# THE VILLAS AT CLAREMONT RANCH

### STREET IMPROVEMENTS PLANS

SF-22-028

## STORM SEWER PLANS

PRIVATE EXTENDED DETENTION BASIN  
SCALE: 1" = 20'

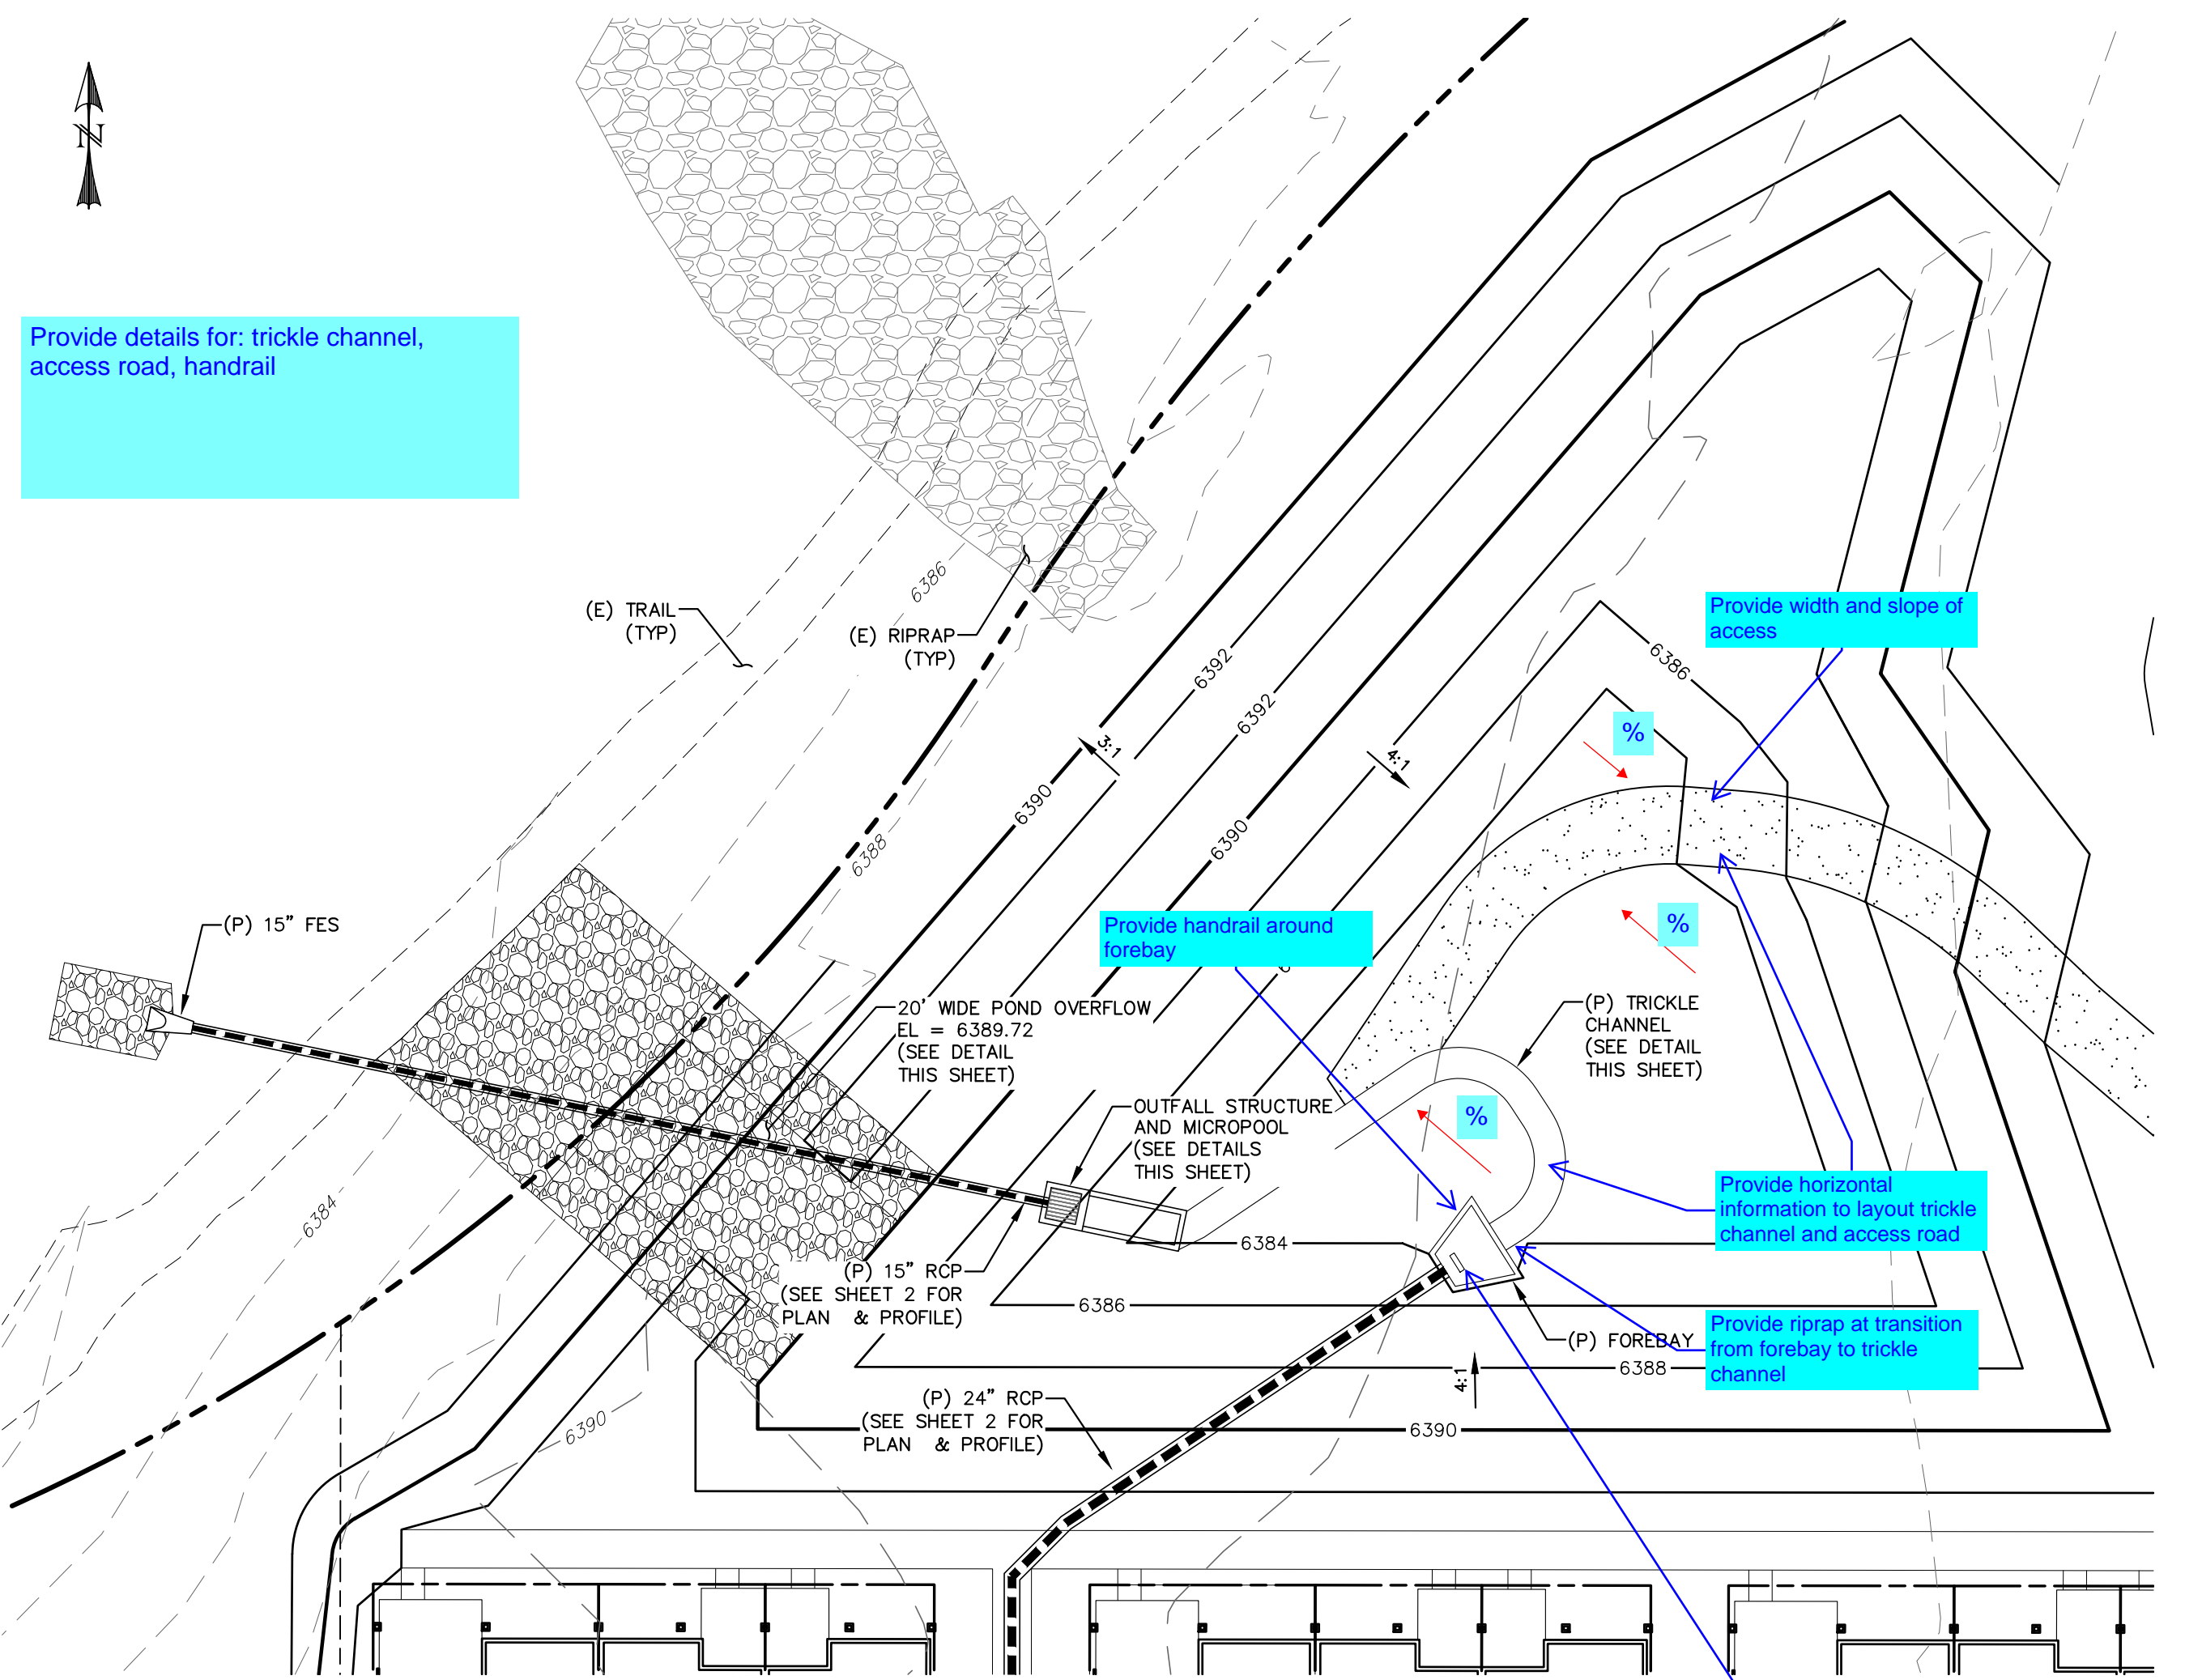
Provide details for: trickle channel, access road, handrail

**THE VILLAS AT CLAREMONT RANCH**  
**POND DETAIL SHEET**

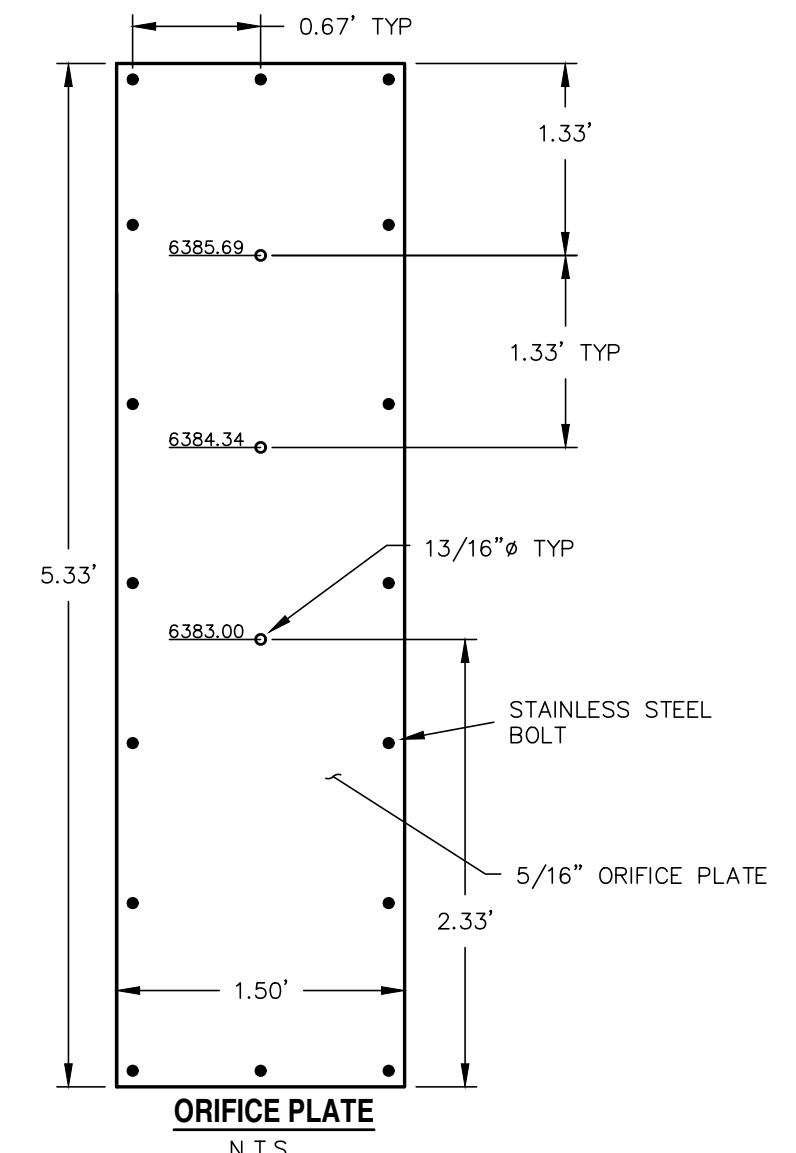
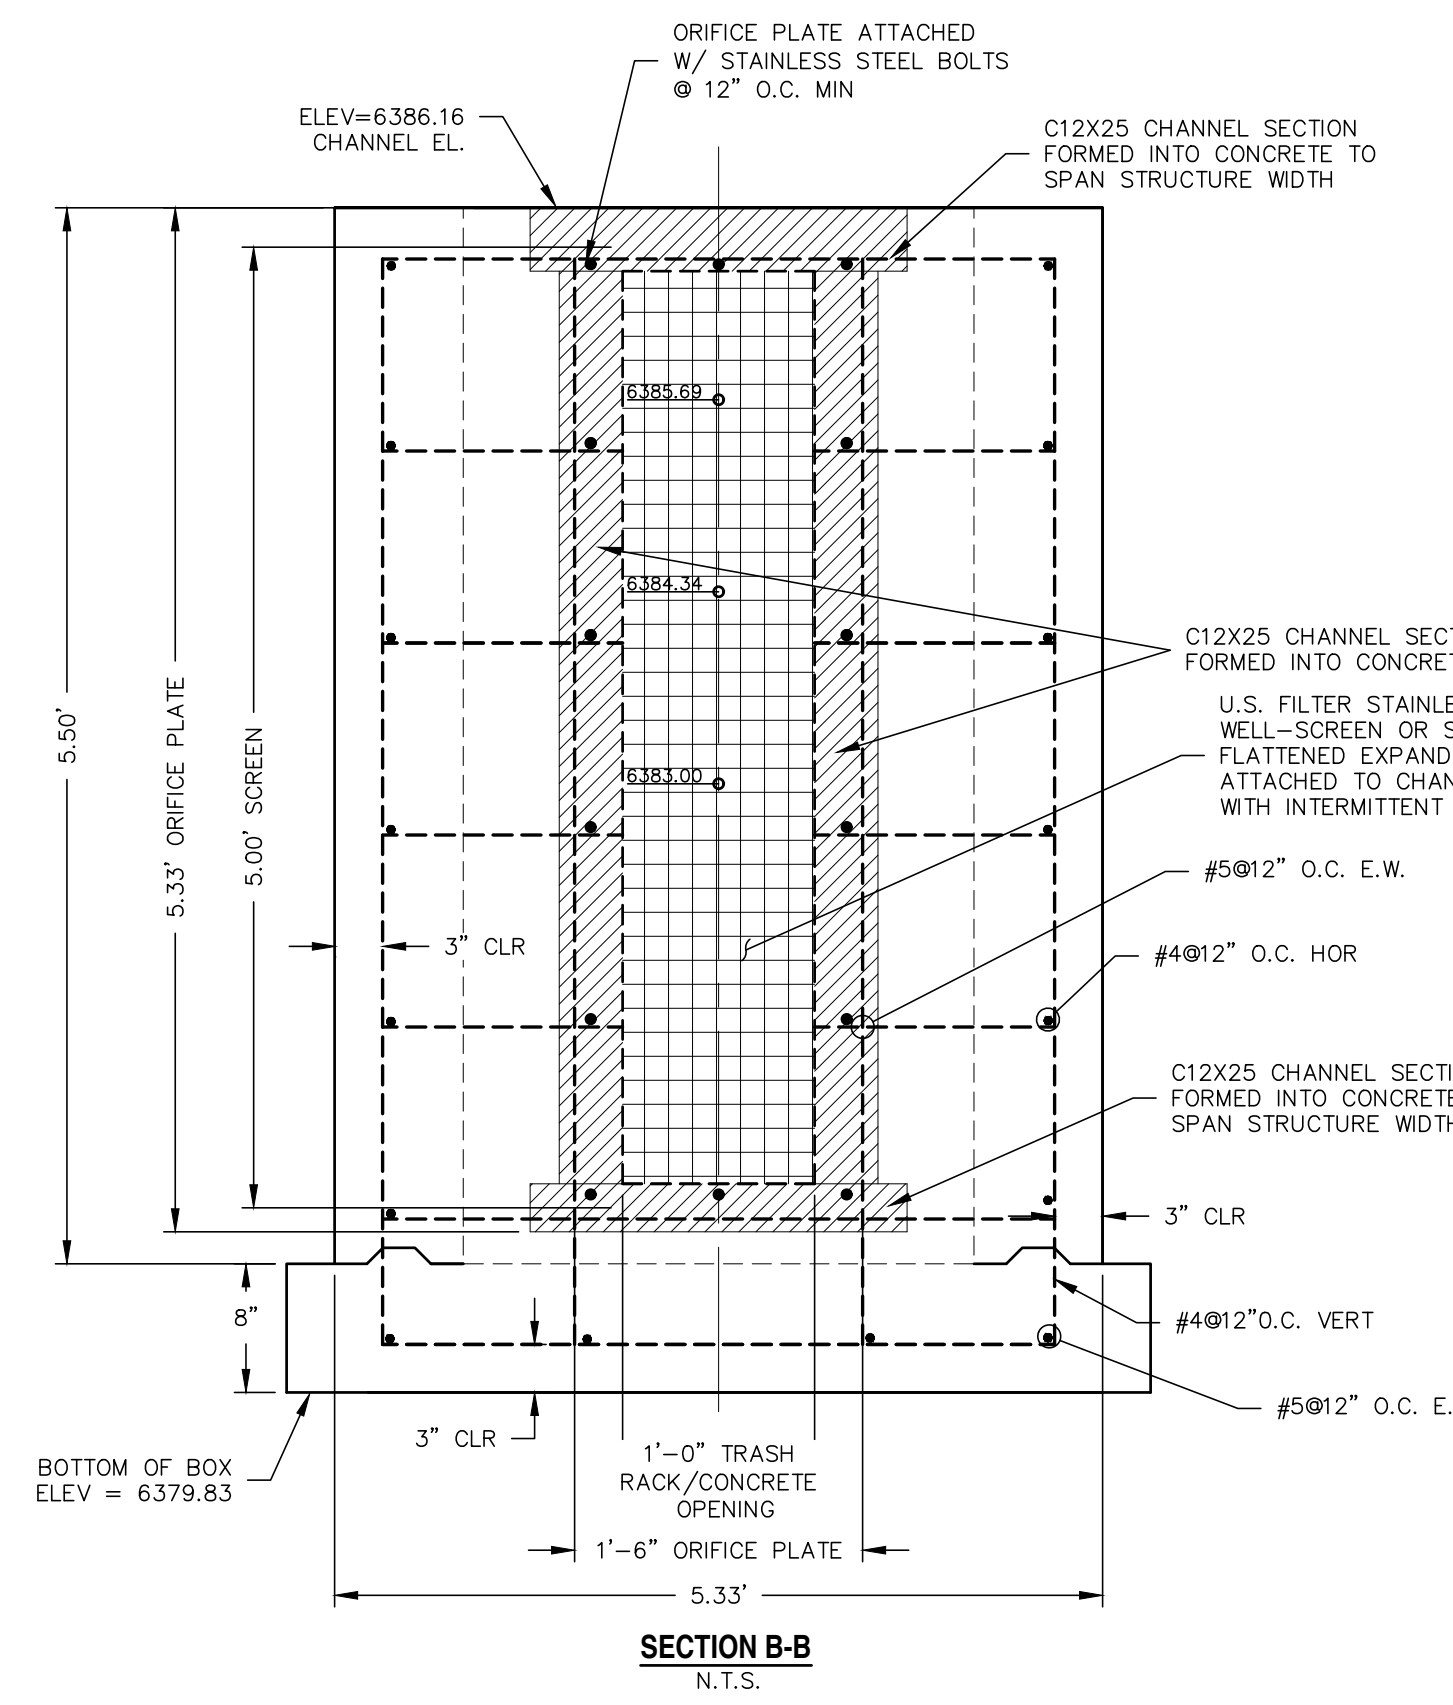
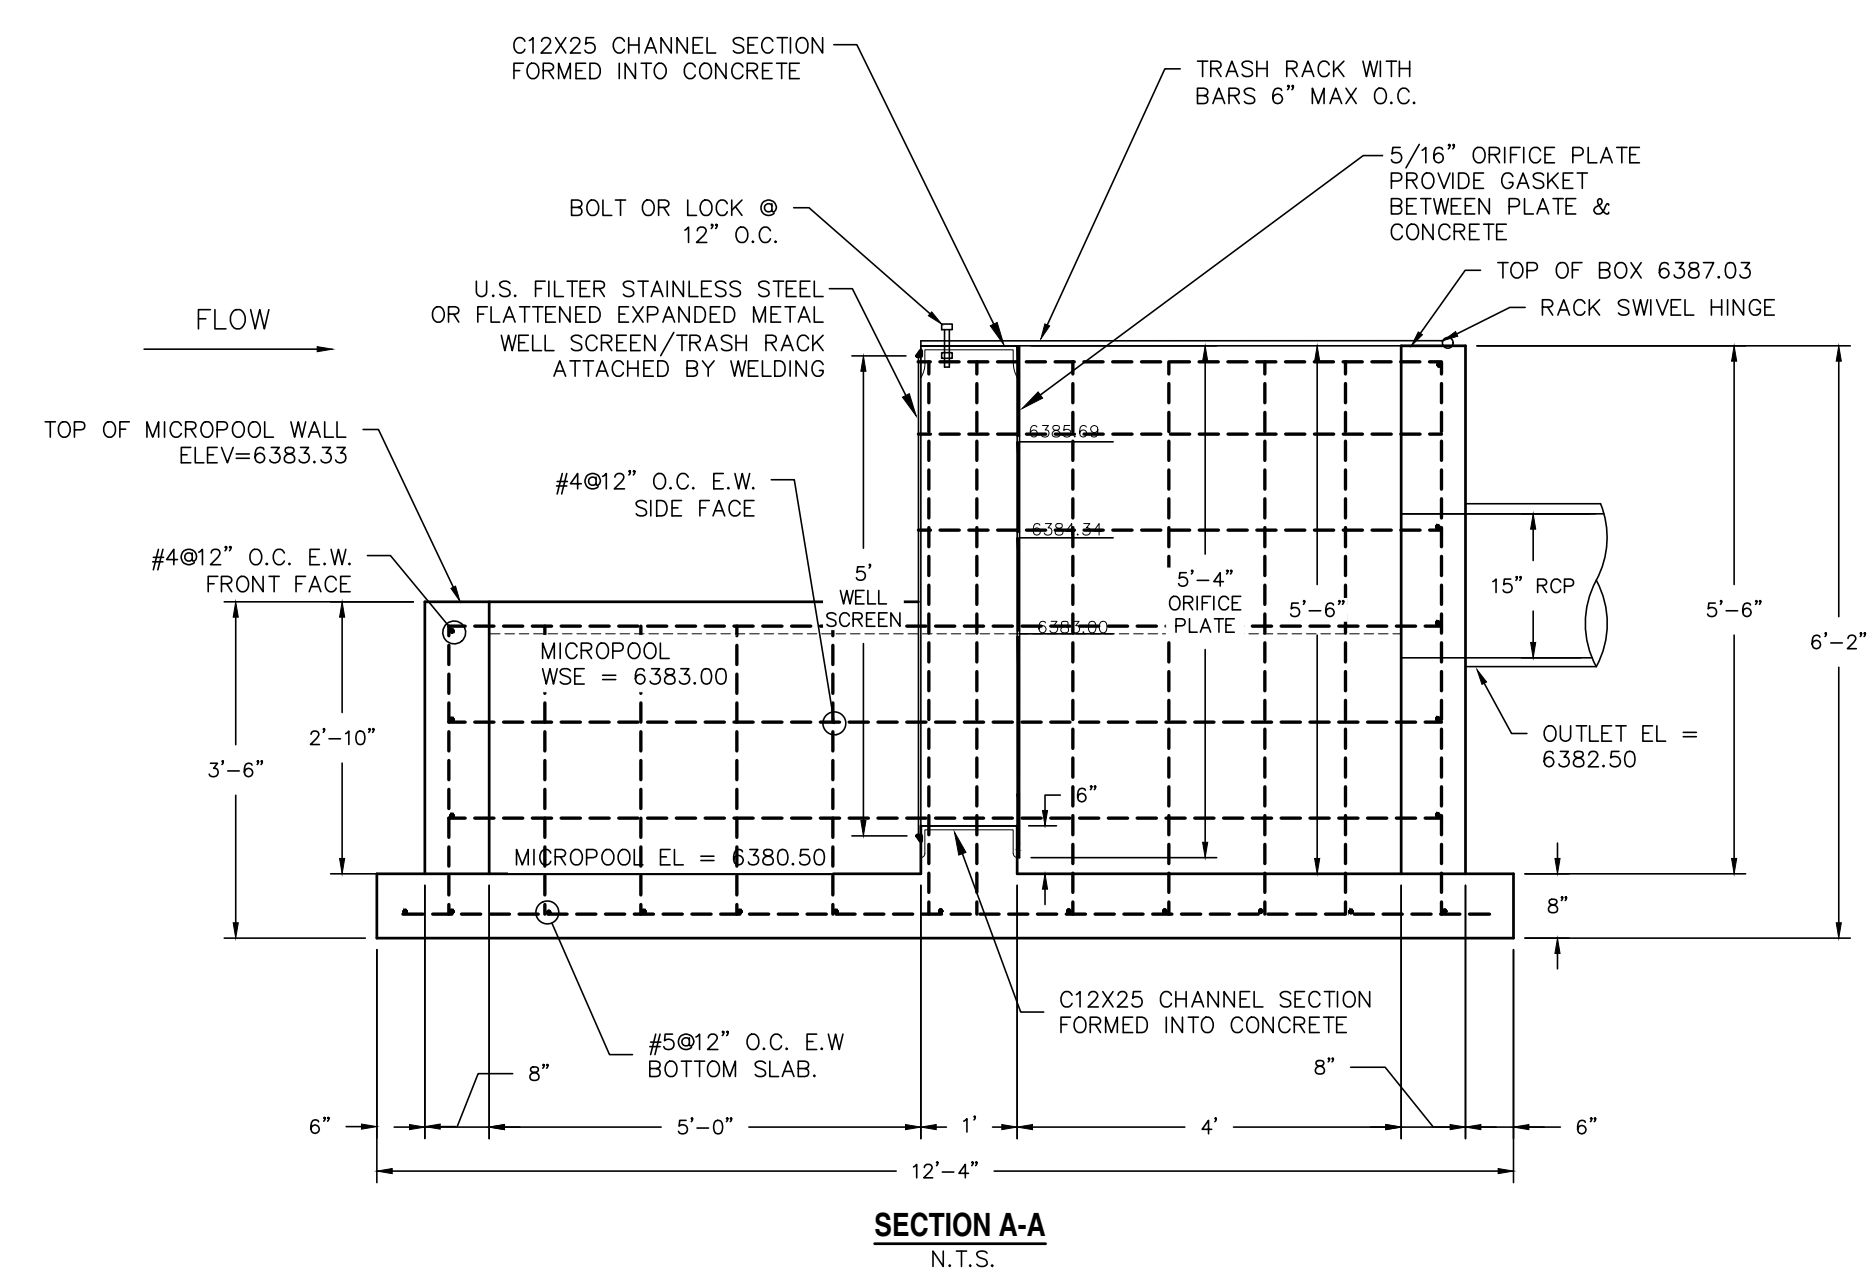
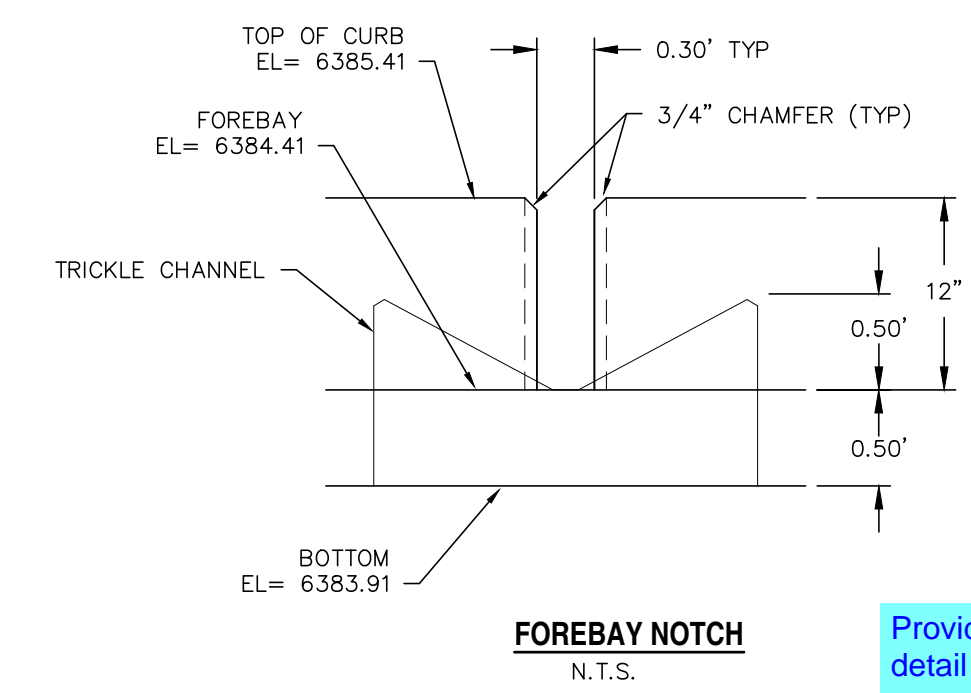
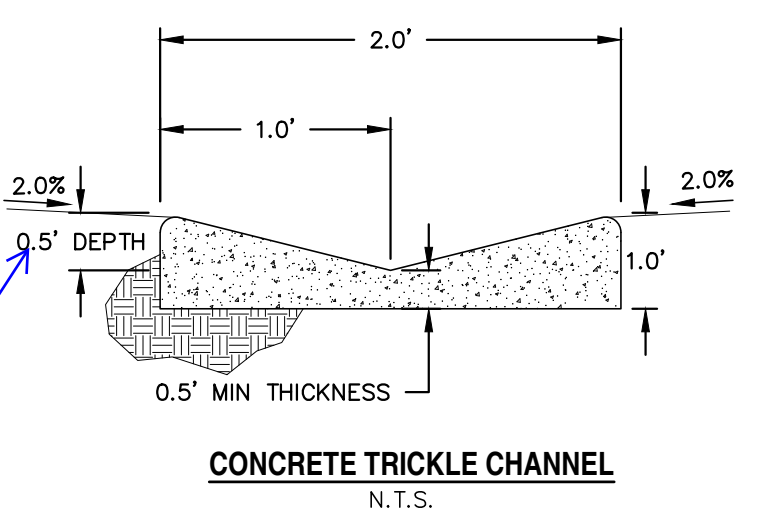
Provide detail for forebay

Per DCM Vol 2 - EDB Low flow channel should be min. 9" deep

Provide reinforcement detail of forebay walls
